H. B. ROBINSON UNIT NO. 2
DOCKET NO. 50-263
LICENSE NO. DPR-23

RESPONSE TO QUESTIONS ON SPENT FUEL SHIPPING CRANE

CP&L RESPONSES TO NRC REQUESTS
FOR ADDITIONAL INFORMATION ON THE
SPENT FUEL CASK HANDLING SYSTEM
H. B. ROBINSON UNIT NO. 2, DOCKET NO. 50-261

PLAN

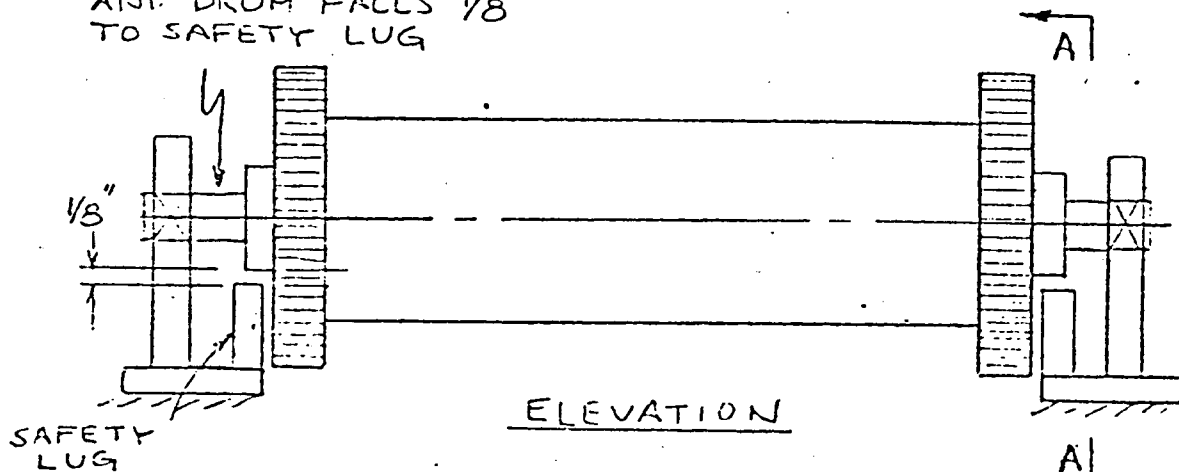
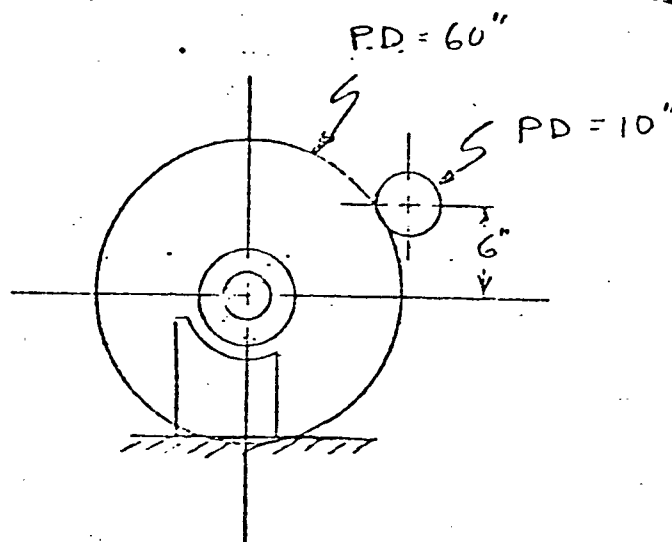
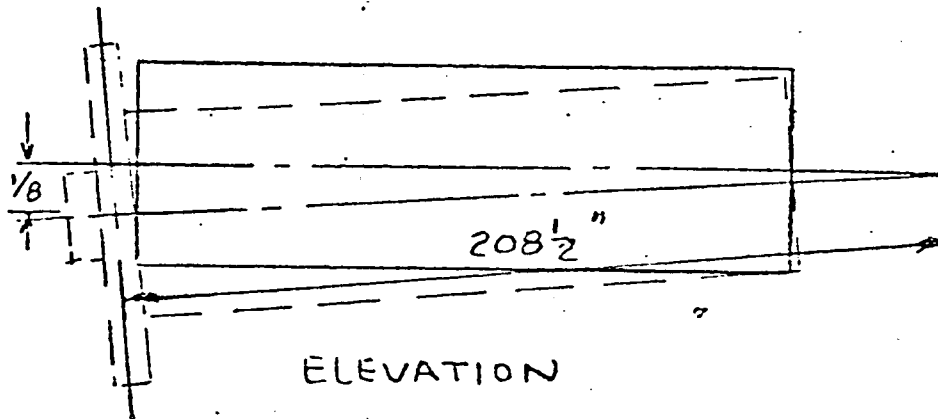
- 3.k. The main hoist drum is a single component, the failure of which would cause loss of the critical load. It is our position that mechanical restraints should be provided which will catch and hold the drum in the event of support failure at one end of the drum and which would allow for emergency lowering of the critical load. Provide details of the drum restraints including the amount the drum can drop in the event of an end support failure. Also, provide an analysis which shows that the misalignment on the gear train opposite the failed support as a result of the drum dropping is within the design limits of the gearing, and that the combination of misalignment and added friction of the drum on the restraint will not cause excessive loading on this gearing during emergency lowering of the load.

Response - Each end of the drum is provided with a hub which is concentric with the drum shaft. A safety lug, (receptacle) is built into the trolley frame on both ends of the drum. The safety lug has a surface which is concentric with the drum hub and is located 1/8" under the drum hub. In the event of failure of a drum shaft or support, the drum hub comes into contact with the safety lug which prevents the drum from falling. An analysis shows that the misalignment on the gear train opposite the failed shaft, or support, as a result of the drum dropping is within the design limits of the gearing, and that the combination of misalignment and added friction of the drum hub on the safety lug will not cause excessive loading on the gearing during emergency lowering of the load. The analysis is attached for information.

ASSUME SHAFT FAILS
AND DRUM FALLS $\frac{1}{8}"$
TO SAFETY LUG
